SUBJECT: Proposed Rule: Safety Standard for Adult Portable Bed Rails

Attachment: Draft *Federal Register* notice "Proposed Rule: Safety Standard for Adult Portable Bed Rails"

Billing Code 6355-01-P

- § 8.4.5.4. Add the following proposed figures (Figure 4a and Figure 4b) for reference for Zone 3 test:

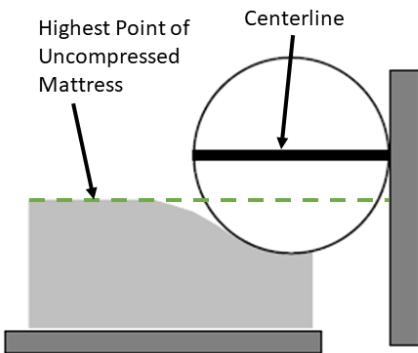
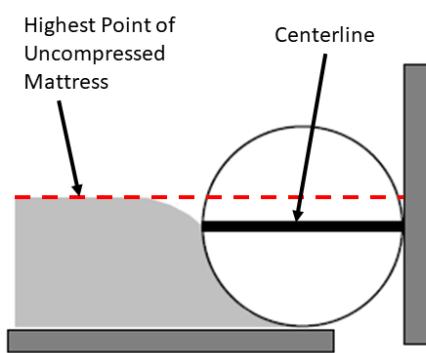
- § 8.4.5.4: Revise “Turn the cone until the centerline on the face of the 4.7 in (119.38 mm) end is horizontal and let the cone sink into the space by its own weight. (1) If the line on the face of the 4.7 in (120 mm) end of the cone is above the surface of the mattress highest point of the uncompressed mattress, as shown in Figure 4a, the space passes the test. (2) If the line on the face of the 4.7 in (120 mm) end of the cone is at or below the surface of the mattress, the space fails the test.” Instead of the “below the surface of the

mattress" insert "below the highest point of the uncompressed mattress, as shown in Figure 4b."

CPSC staff's review showed that the Zone 3 entrapment performance requirement in section 6.3.3 is redundant due to the failure criteria described in the associated test method, section 8.4.5.4. To ensure consistency, proposed revisions to these sections more accurately describe the test method for the highest level of safety and are also more consistent with the FDA guidance document referenced in the standard. In addition, the Figures 4a and 4b are proposed to assist testers in visualizing the test criteria.

Figure 4a: Zone 3 Pass Criteria
(Centerline above highest point of uncompressed mattress)

Figure 4b: Zone 3 Fail Criteria
(Centerline below highest point of uncompressed mattress)

Figure 4 Zone 3 test: (a) Pass, (b) Fail

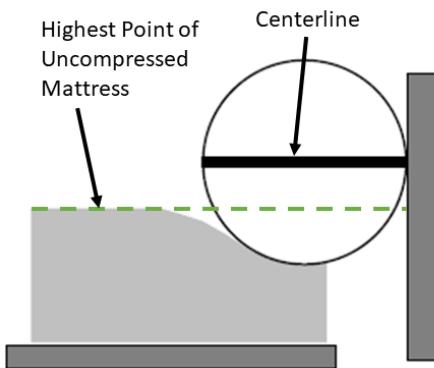
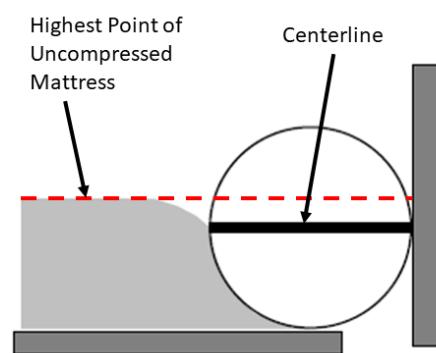
(a) If the line on the face of the 4.7 in (120 mm) end of the cone is above the highest point of the uncompressed mattress, as shown in Figure 4a, the space passes the test.

(b) If the line on the face of the 4.7 in (120 mm) end of the cone is at or below the highest point of the uncompressed mattress, as shown in Figure 4b, the space fails the test.

Proposed Figures for § 8.4.5.4 Reference, Figure 4a and 4b: Zone 3 test: (a) Pass, (b) Fail

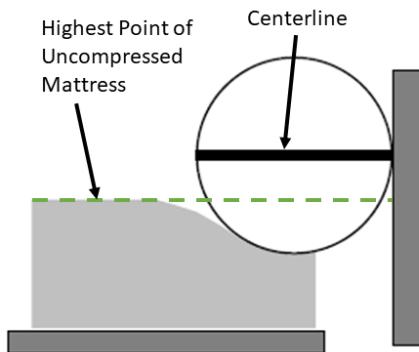
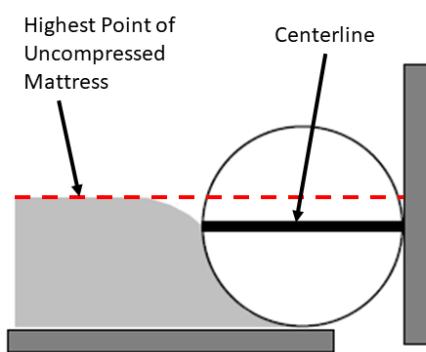
- (1) If the line on the face of the 4.7 in (120 mm) end of the cone is above the surface of the mattress highest point of the uncompressed mattress, as shown in Figure 4a, the space passes the test.
- (2) If the line on the face of the 4.7 in (120 mm) end of the cone is at or below the surface of the mattress highest point of the uncompressed mattress, as shown in Figure 4b, the space fails the test.

Rationale: The Zone 3 entrapment performance requirement in section 6.3.3 is redundant due to the failure criteria described in the associated test method, section 8.4.5.4. The failure criteria described in the test method is the intended requirement, which would also be more consistent with the FDA guidance document referenced in the standard and is the interpretation in favor of safety. In addition, the Figures are proposed to assist testers in visualizing the test criteria.³⁶

³⁶ The proposed Figure 4 would not replace the existing Figure 4 in the standard. The existing Figure 4 will be renumbered to Figure 5, and all citations will be adjusted accordingly.

Figure 4 Zone 3 test: (a) Pass, (b) Fail

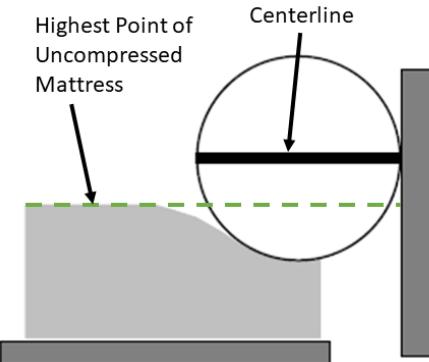
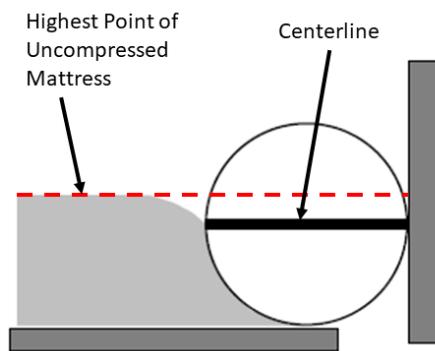
(1) If the line on the face of the 4.7 in. (120 mm) end of the cone is above the surface of the mattress highest point of the uncompressed mattress, as shown in Figure 4a, the space passes the test.

(2) If the line on the face of the 4.7 in. (120 mm) end of the cone is at or below the surface of the mattress highest point of the uncompressed mattress, as shown in Figure 4b, the space fails the test.

Rationale: The Zone 3 entrapment performance requirement in section 6.3.3 is redundant due to the failure criteria described in the associated test method, section 8.4.5.4. The failure criteria described in the test method is the intended requirement, which would also be more consistent with the FDA guidance document referenced in the standard and is the interpretation in favor of safety. In addition, the Figures are proposed to assist testers in visualizing the test criteria.²
